Sheet: /
 File: working.kicad_sch

Title: UTCape

Rev: 1

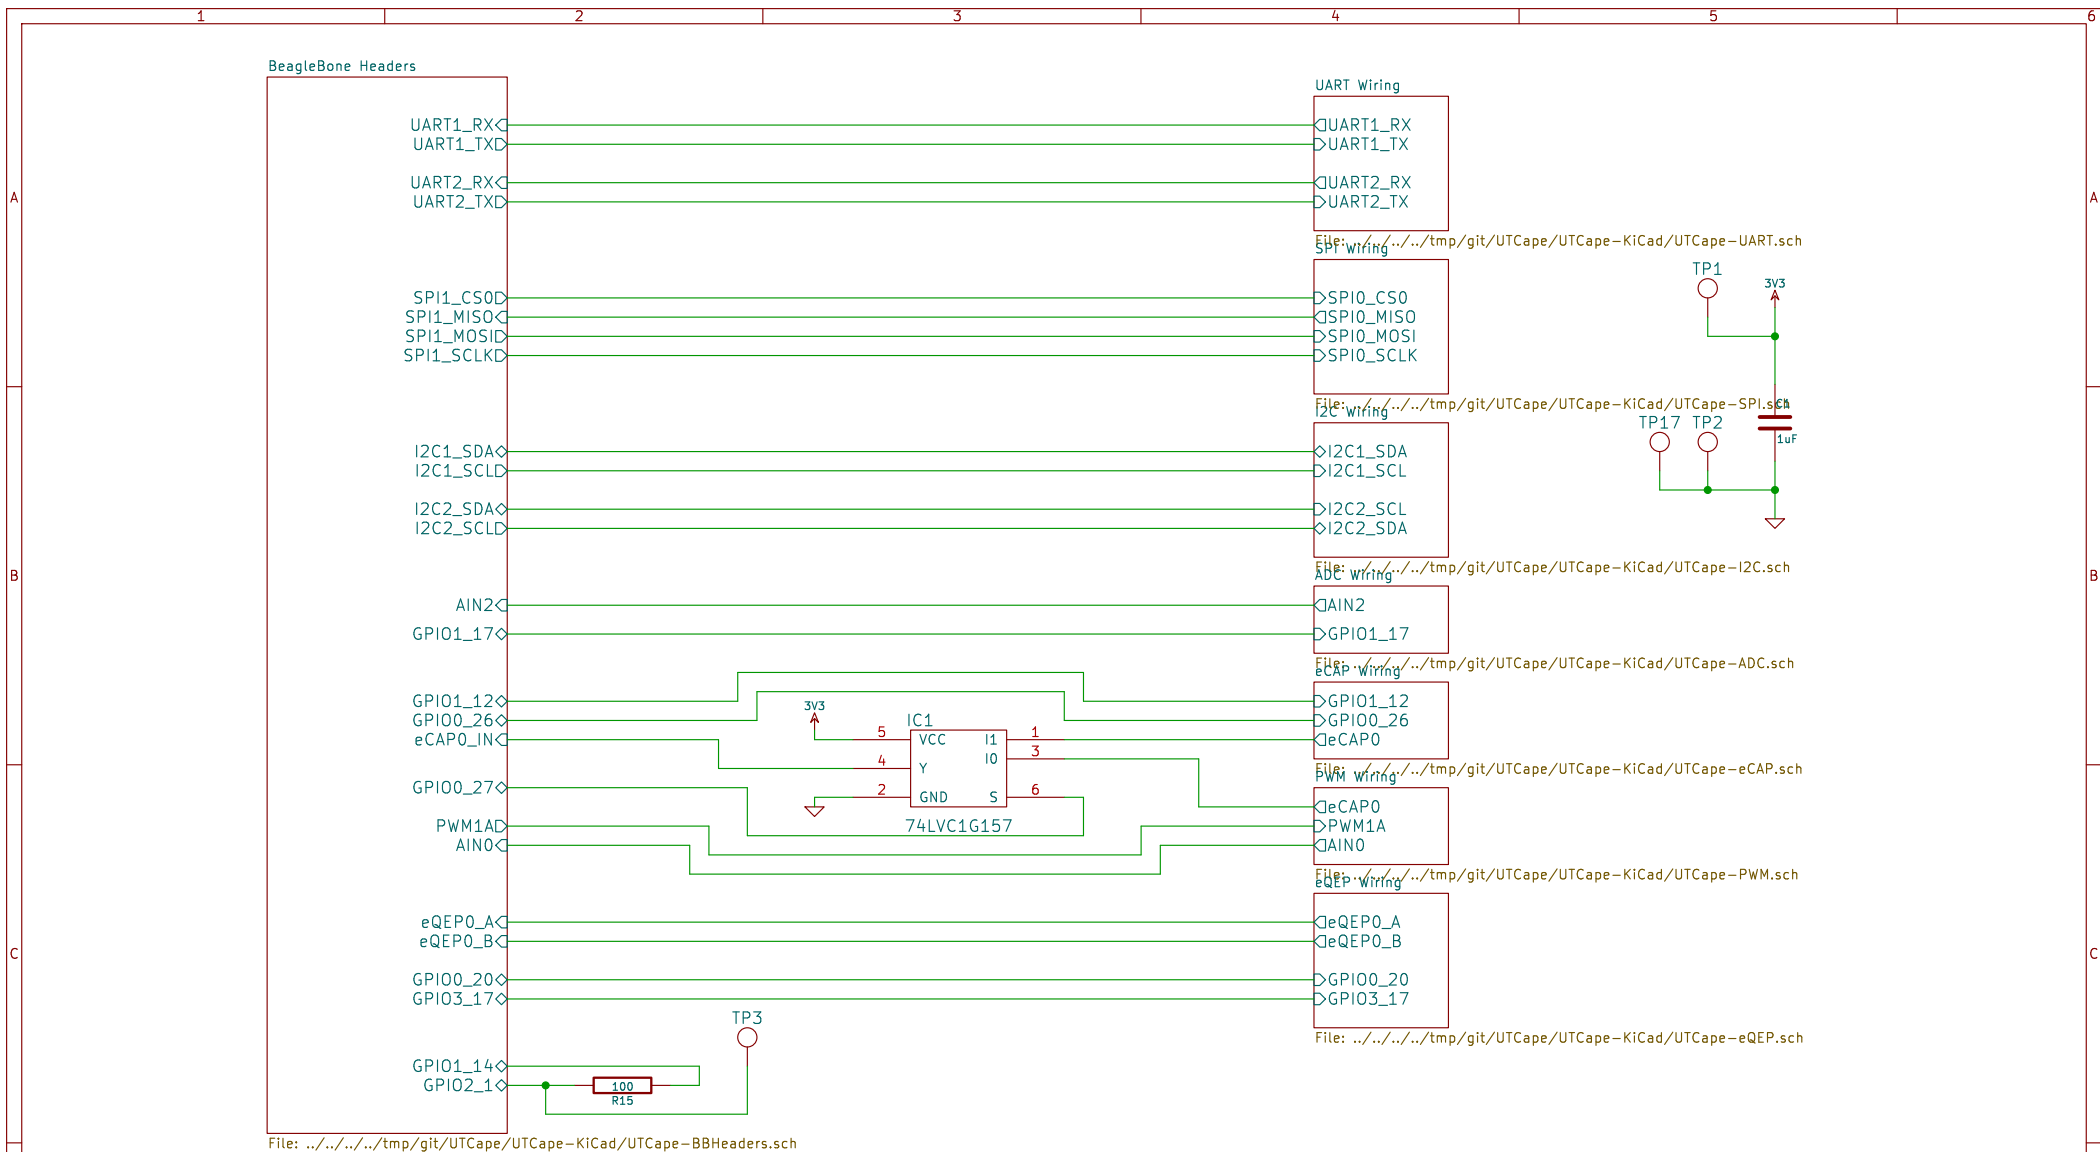
1. Is IC1 really needed, or am I just not seeing a second eCAP input?
